CREATIVE SPACE SITE PLAN REVIEW (PLN50177 SPR)

Re:	Permit Number:	PLN50177 SPR
	Applicant:	TSENG Properties, LLC
		PO Box 11765
		Bainbridge Island, WA 98110
Project:		Creative Space Site Plan and Design Review

Staff Report

Project: Creative Space Site Plan and Design Review

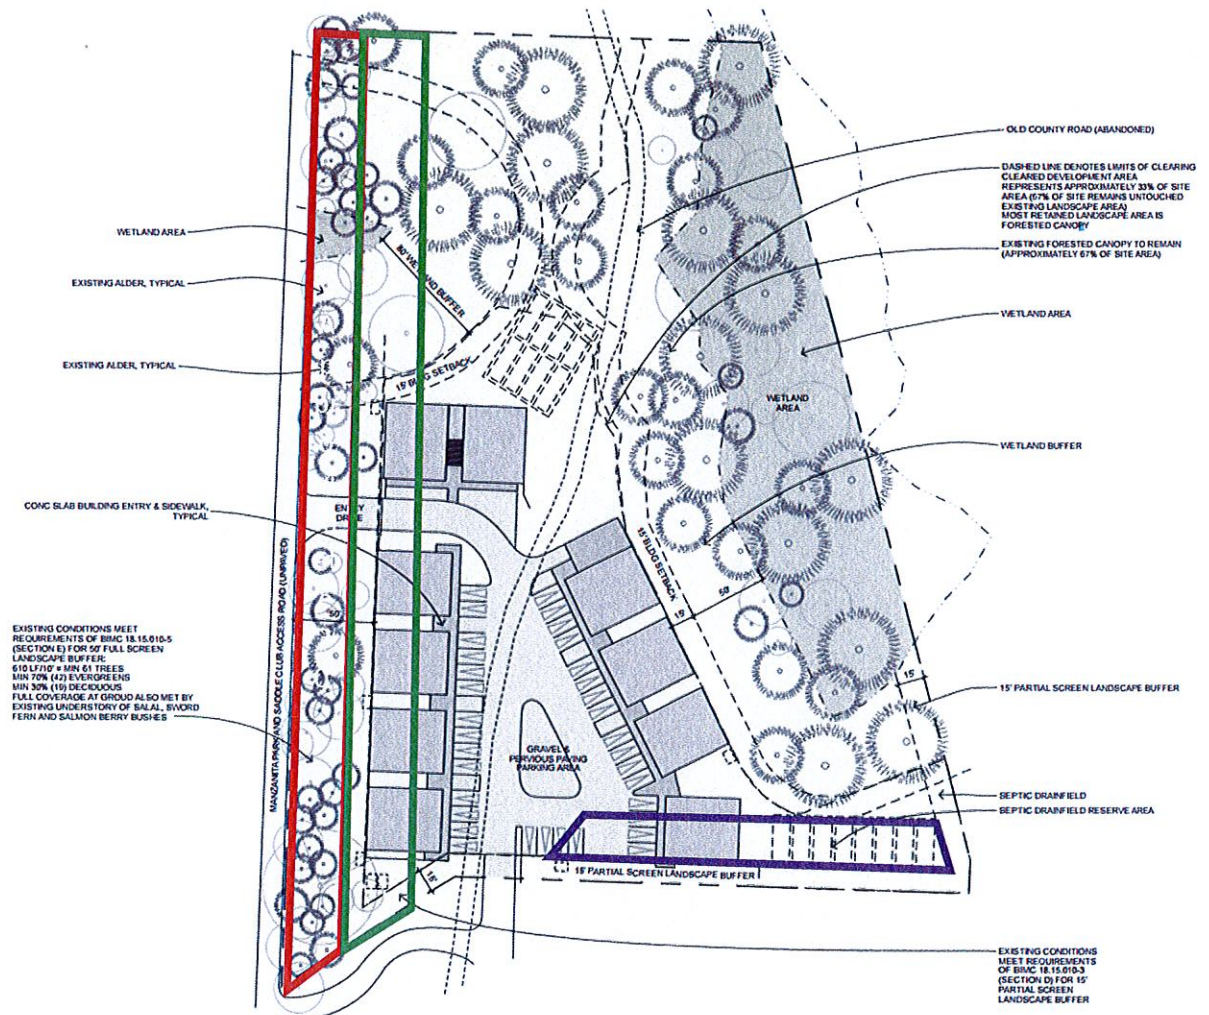
The property abuts a private road that is shared with the Saddle Club. The road is accessible with a 60' access easement, 30' of which are on the subject property. Thirty feet east of the road is an easement that has been left in its vegetative state. As part of the project, the intention is to leave this easement in its vegetative state, except to enhance it with a trail for pedestrians and horses. Five of the western most buildings are proposed within the 50' perimeter landscape buffer. The 50' landscape buffer was adopted through Ordinance 2016-1. Previously, it had been 30'. Since the ordinance was adopted on March 22, 2016, which was after this application had been filed with the City and approved by the Design Review Board, the application must be reviewed under the requirements of the 30' landscape buffer. For a more detailed explanation of the applicant's position, please refer to the April 17, 2017, letter submitted by the applicant's counsel to the City. A second 50' access and utility easement exists on the southern border of the property, running east/west. The applicant is proposing to include within that easement area one of the buildings, a landscaping buffer, parking, and drainfields. This easement wasn't included in the applicant's proposed site plans. In researching the site, the City discovered the easement and informed the applicant about the existence of the easement. When so informed by the City, the applicant responded by indicating that they would vacate the easement, without specifying how this would be accomplished (reference doc 19). Certain members of the applicant own and control the company that has the legal rights to the easement. As such, they are in the position to extinguish it. Moreover, approval of the application can be made subject to the extinguishment of the easement.

The property has two wetlands and associated buffers. The site plan does not propose any encroachments into the wetlands and their buffers (reference doc 6). However, stormwater is proposed to discharge to a wetland at the outfall of a replaced culvert proposed to be located opposite the access point along Saddle Club road. The applicant was asked to address the potential impacts on the wetland. This information has not been provided to the City. The applicant's civil engineer, Adam Wheeler, did submit a response to the City's concern, which addressed it. If there are further concerns, approval can be made subject to addressing the concerns.

In the preparation of this staff report, comments were received from the City's surveyor regarding the 30' easement on the property. While reviewing the easement, the surveyor also noted a 50' access and utilities easement on the south side of the subject property. This easement was not depicted on any of the drawings submitted by the applicant. The 50' easement was established in 1991 and was to serve the southern lot and the adjoining lot to the east. The site plan depicts development in this easement area. The City cannot approve the proposed development as depicted because it would impede ingress and egress access to the adjoining property. The project site plan proposes a building, landscaping, a drainfield, and parking within the access easement, which would violate the rights of the easement holder without consent of the current easement holder to abandon this easement. **Again, approval of the application can be made contingent on the applicant obtaining consent from the current easement holder to abandon this easement.**

Approximate 30' easement
 Approximate 50' landscape buffer
 Approximate 50' easement
